**GENOA CHARTER TOWNSHIP
PLANNING COMMISSION
PUBLIC HEARING
JULY 11, 2022
6:30 P.M.
AGENDA**

Attention:	Kelly Van Marter, AICP Planning Director and Assistant Township Manager
Subject:	St. Joseph Mercy Health System – PUD Amendment and Site Plan Review #3
Location:	7575 Grand River Avenue – north side of Grand River, west of Bendix Road
Zoning:	NRPUD Non-Residential Planned Unit Development

**Re: St. Joseph Mercy Hospital
Site Plan Review No. 3**

SHEET TITLE
EXTERIOR BUILDING ELEVATIONS & EXTERIOR FINISH SCHEDULE

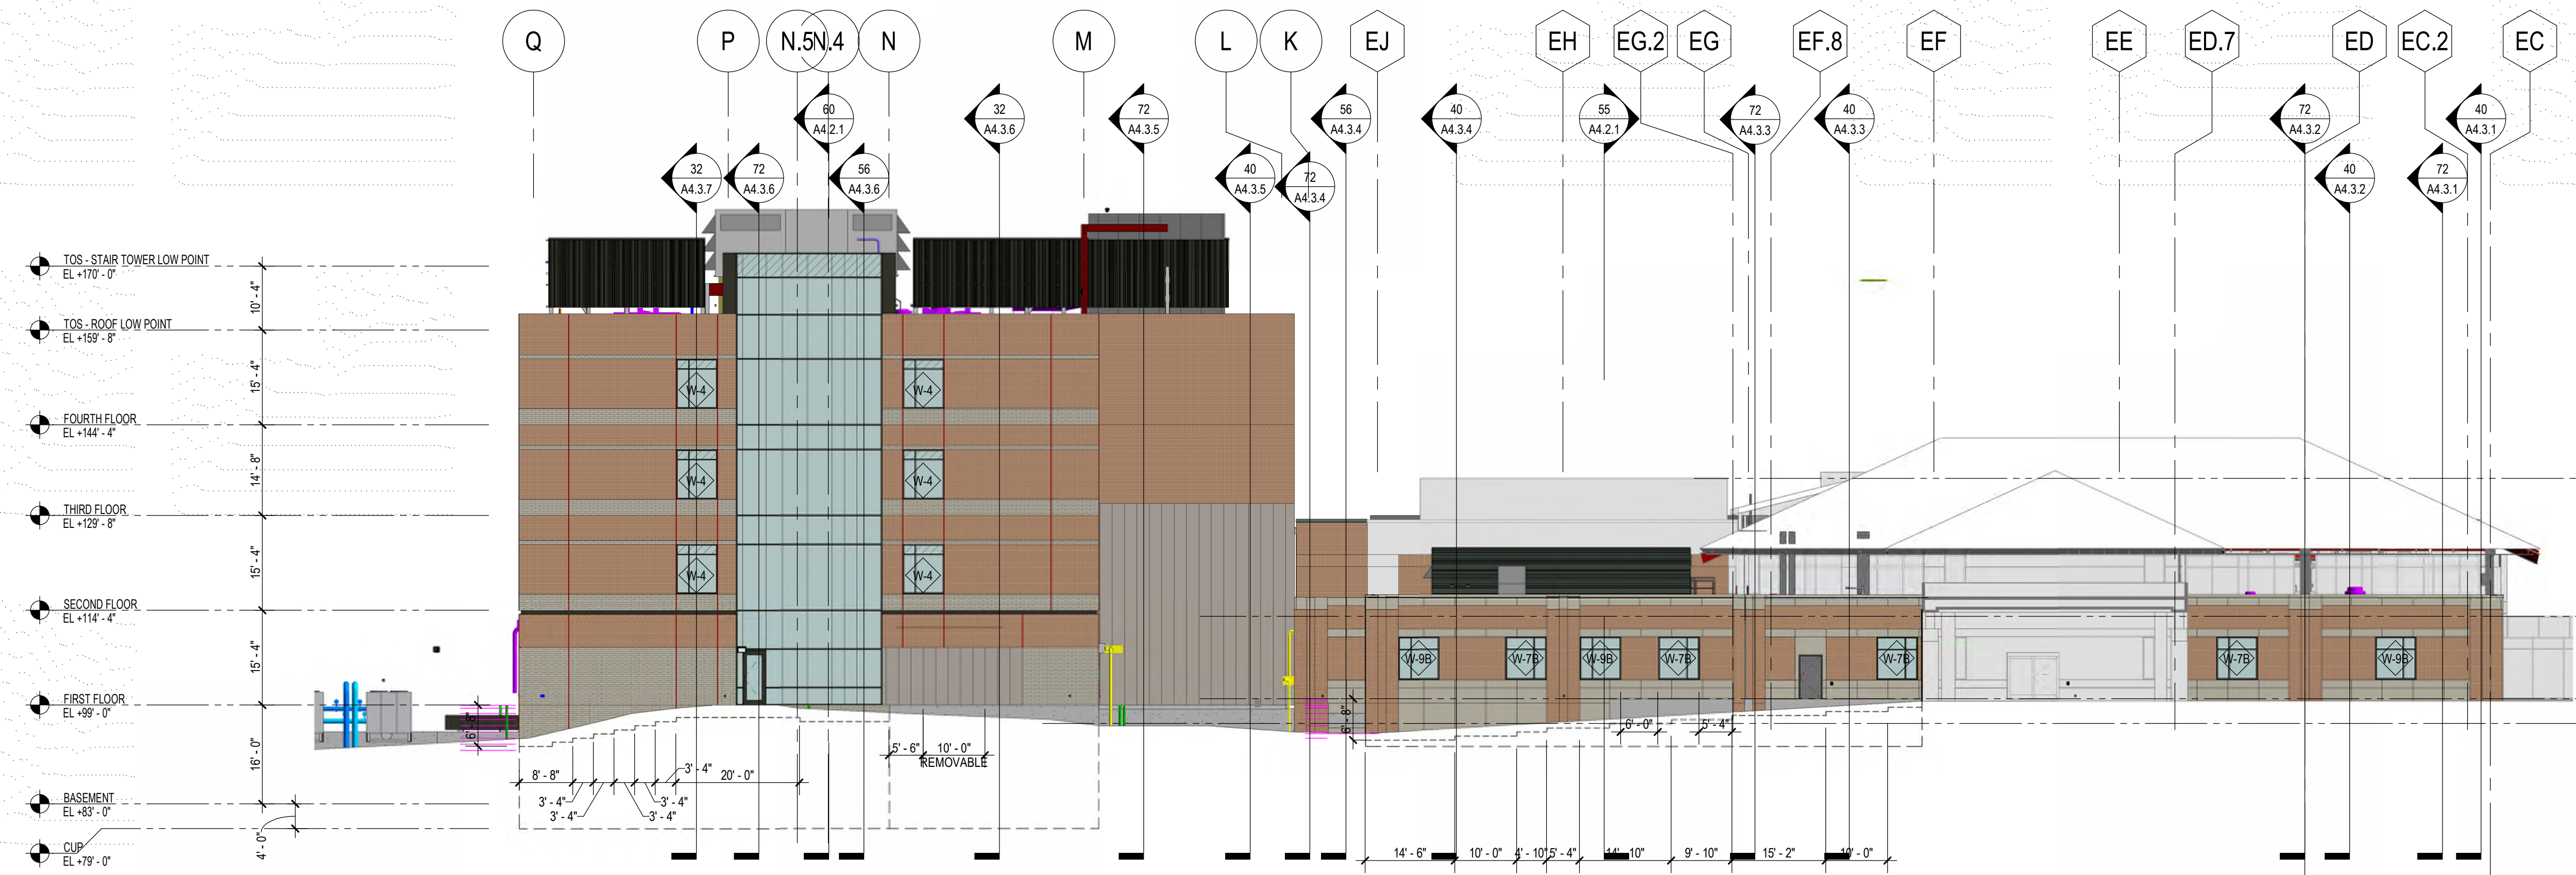
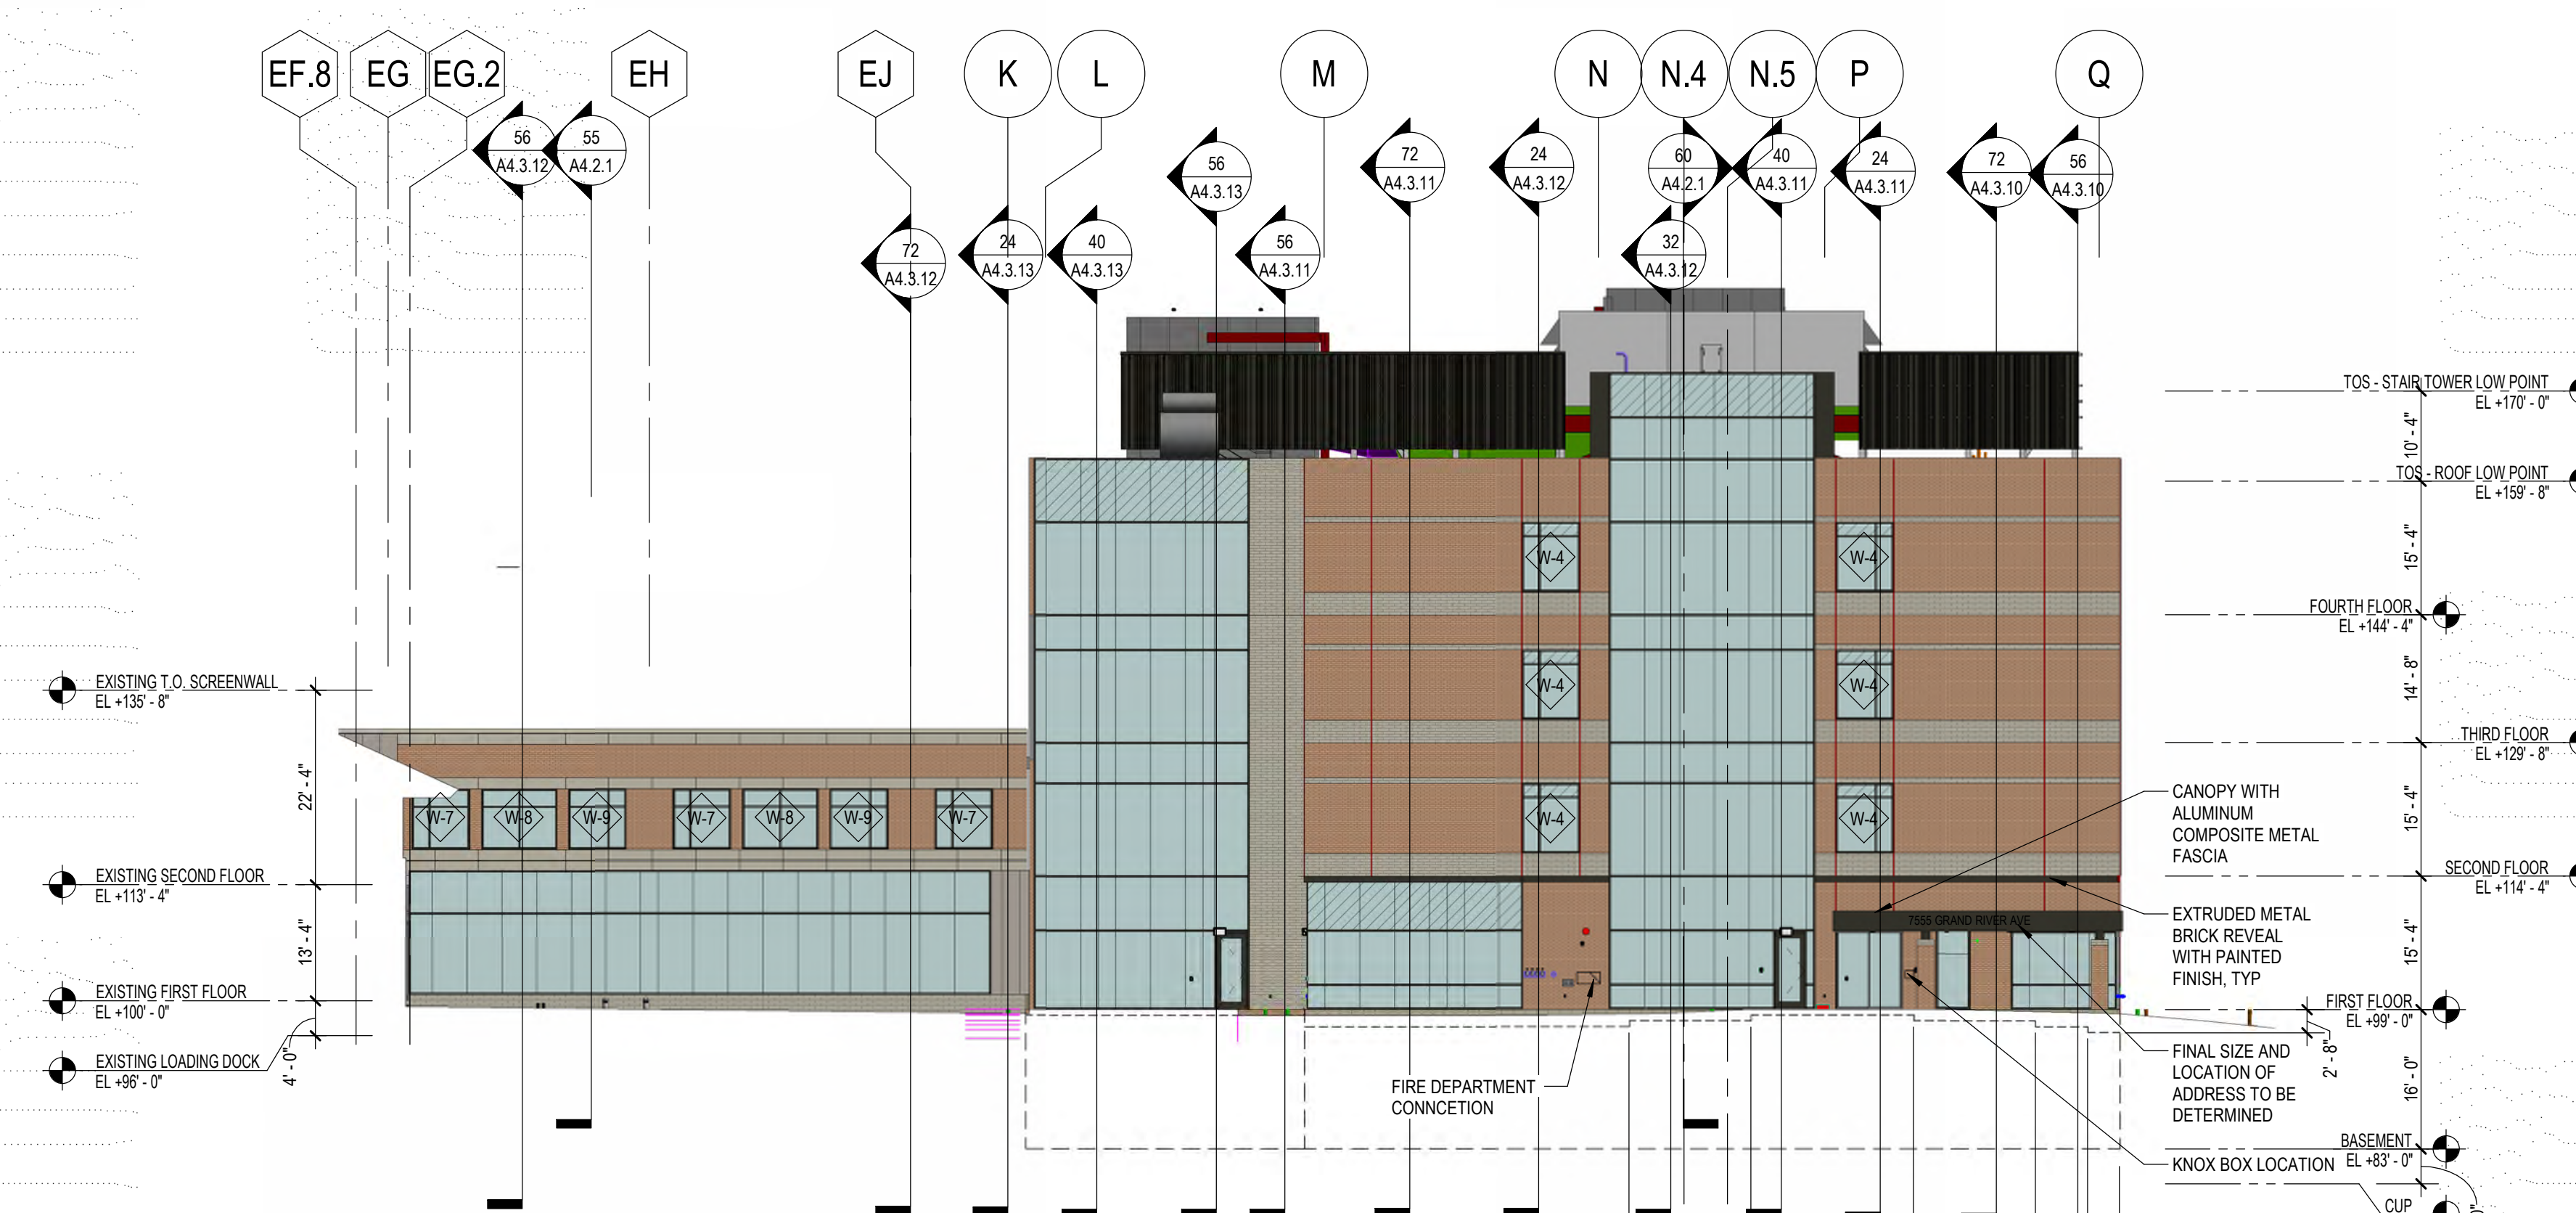
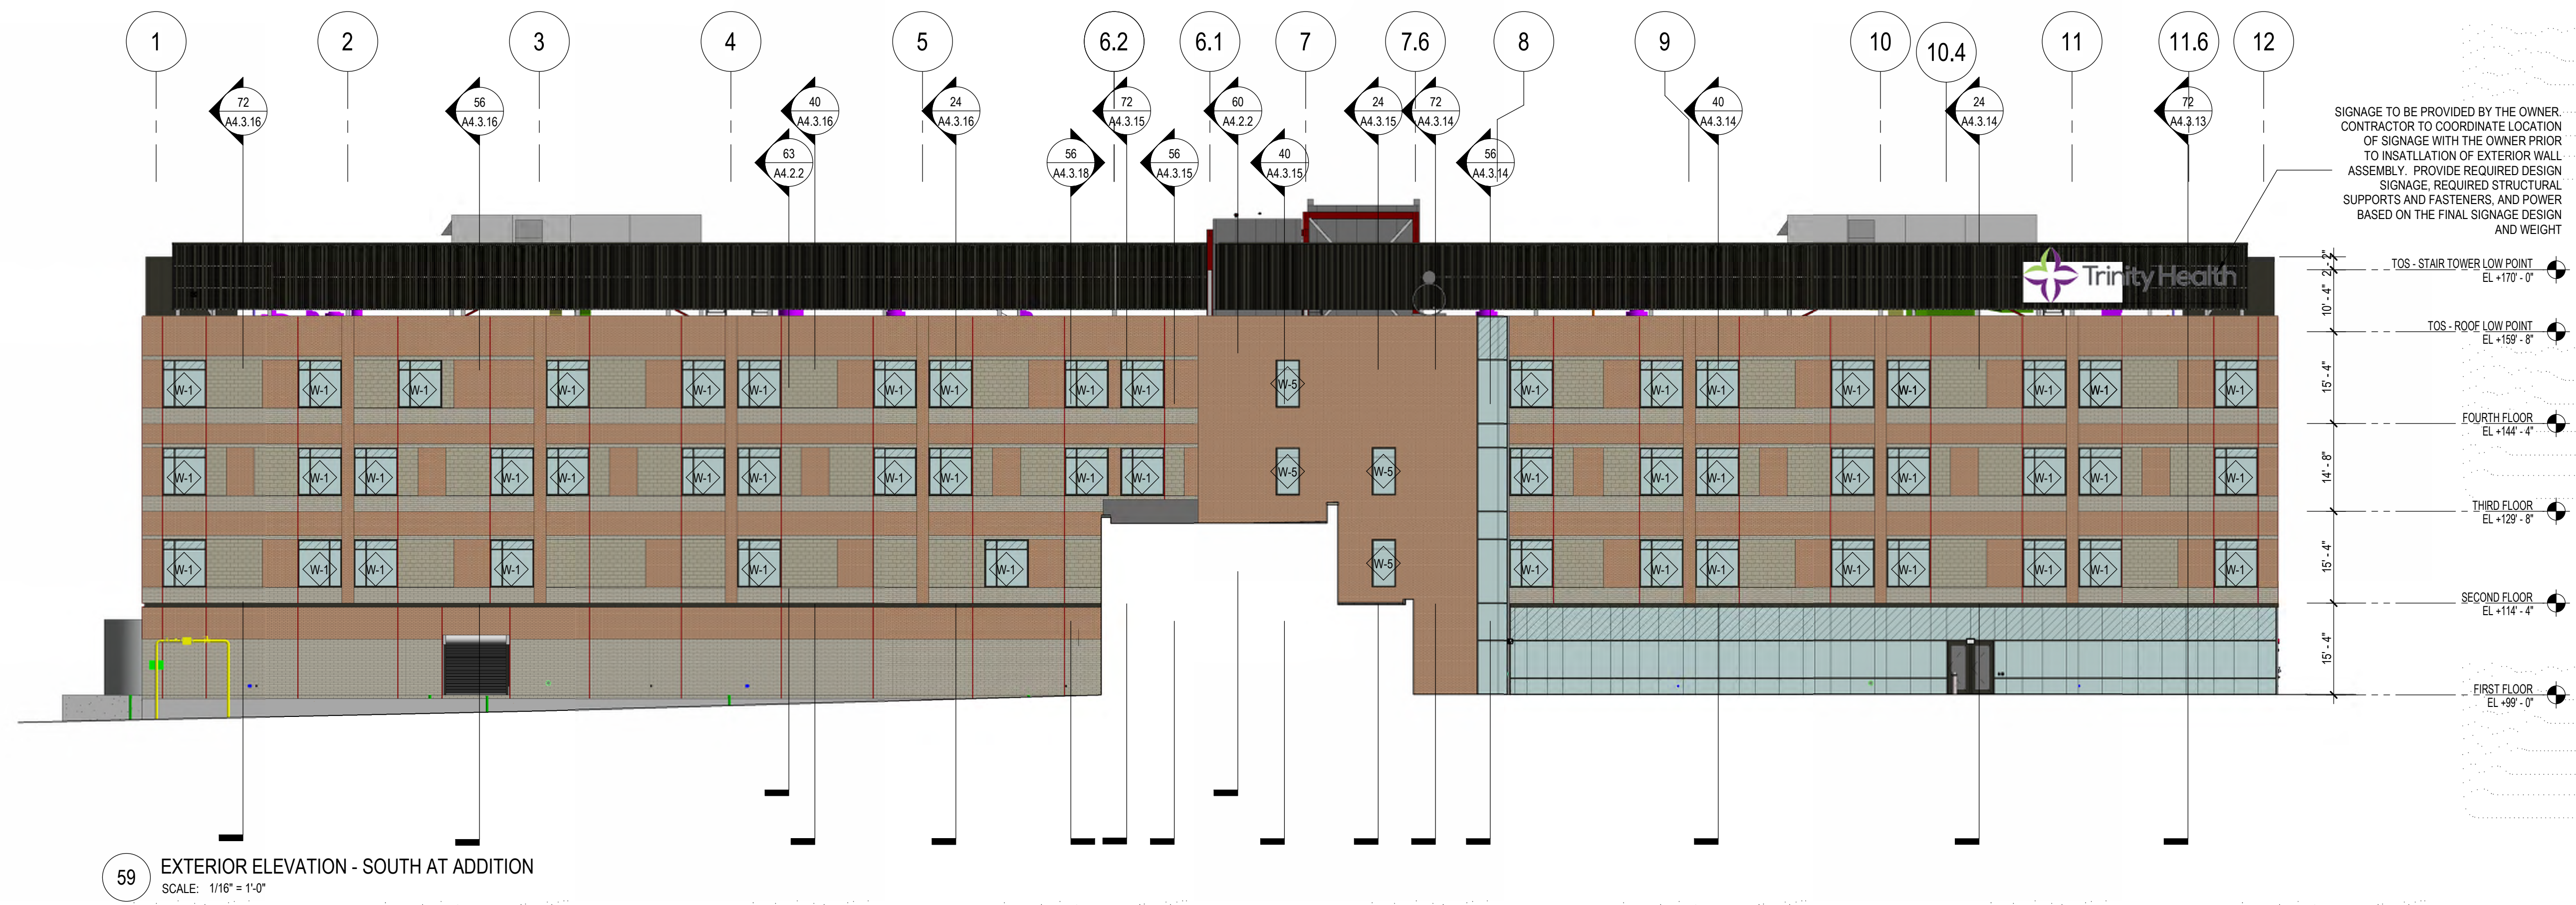
The notes on Sheet A4.1.1 reference Sheet A0.X for the material codes, though this sheet has yet to be provided to our office as part of this review. This document must be provided to the Township for their files.

Building materials and design are subject to review by the Planning Commission, and the applicant should be prepared to present material and color samples at the upcoming meeting.
